# DEVELOPMENT REVIEW BOARD REPORT

MEETING DATE: June 9, 2005

CASE NUMBER/ PROJECT NAME	<b>4-DR-2005</b> <b>The Borgata Of Scottsdale</b>		
LOCATION	6166 N Scottsdale Road		
REQUEST	Request approval of site plan for redesign/remodel of existing shopping center and associated parking, and to add two (2) new restaurant pads. Further, the applicant is requesting architectural approval for an entry patio, water feature, and associated landscaping on the site. Separate DRB approvals will be required for architectural approval of the two (2) new restaurant pads at a future date.		
OWNER	Westcor Partners 602-953-6296	ENGINEER	Val-Tec 602-265-6417
ARCHITECT/ DESIGNER	Sixty First Place Architects 480-947-6844	APPLICANT/ COORDINATOR	Rafique Islam Sixty First Place Architects 480-947-6844
BACKGROUND	<p><b>Zoning.</b></p> <p>The property is currently zoned C-2, and contains an existing retail shopping center.</p> <p><b>Context:</b></p> <p>The site is located just south of Lincoln, fronting Scottsdale Road (Western Side) The area is generally characterized by resort hotels and commercial retail and office land uses.</p> <p>Adjacent Uses:</p> <ul style="list-style-type: none"><li>• North: Exist

**Borgata of Scottsdale** view of fountain

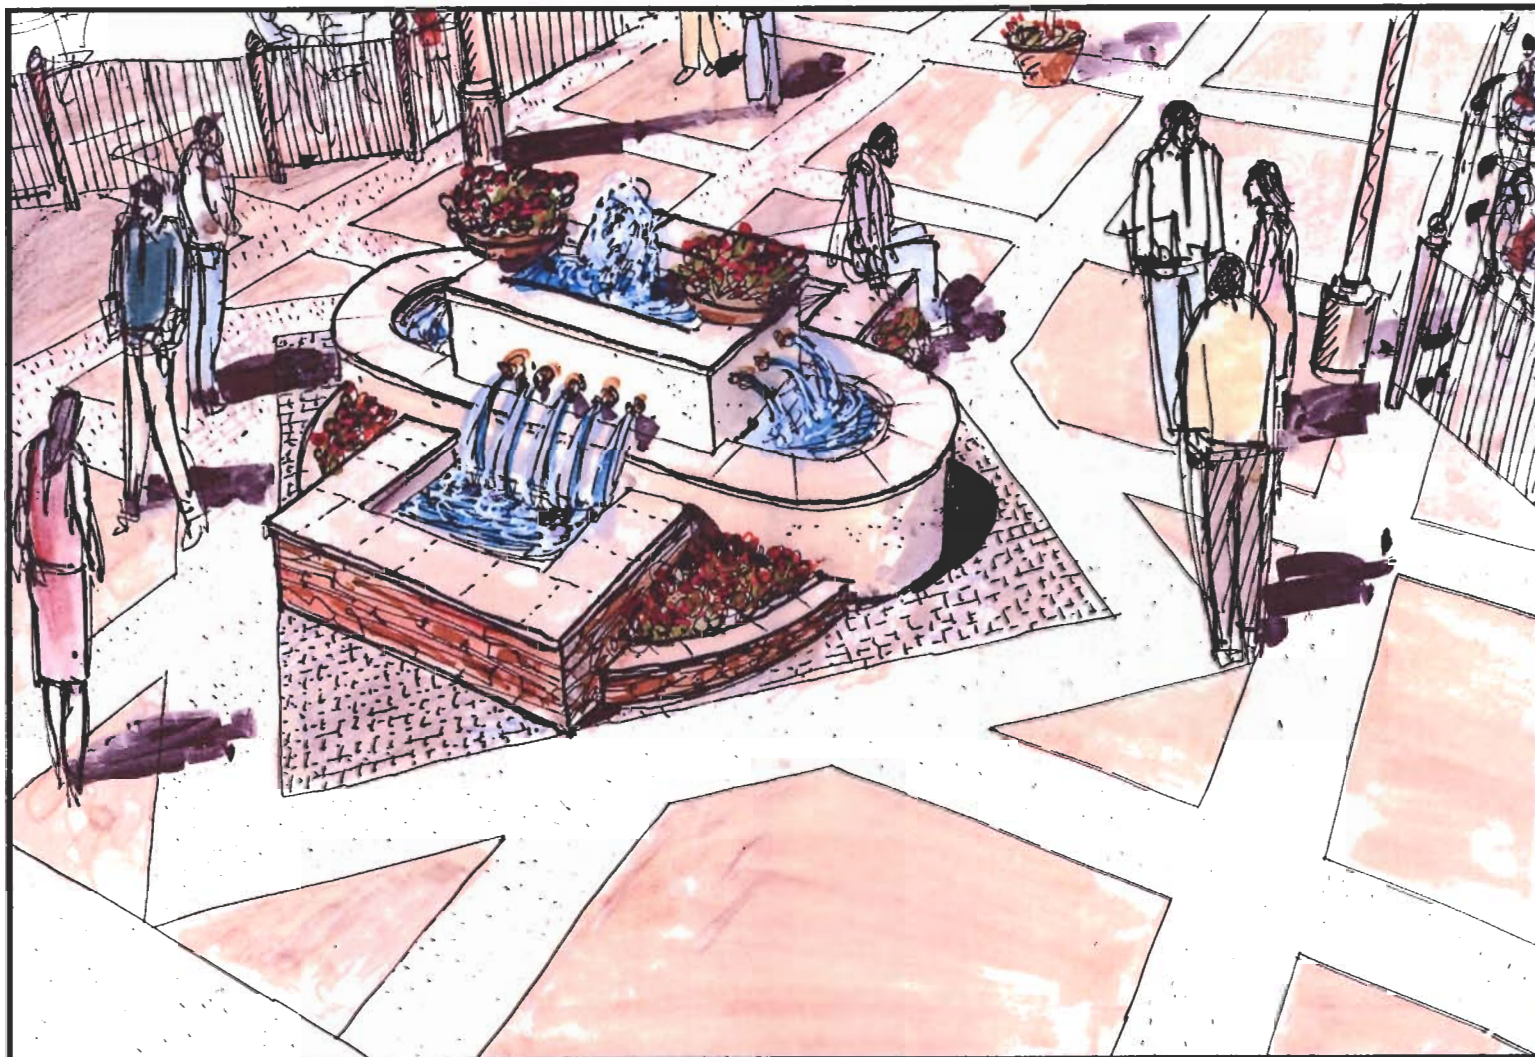
**8. *Height of the fountain: Can it be taller, i.e., a bigger "statement?"***

**Staff Response:** Due to the City's water conservation policy, staff recommends against changing the height of the proposed fountain. The applicant prefers the lower scale fountain.
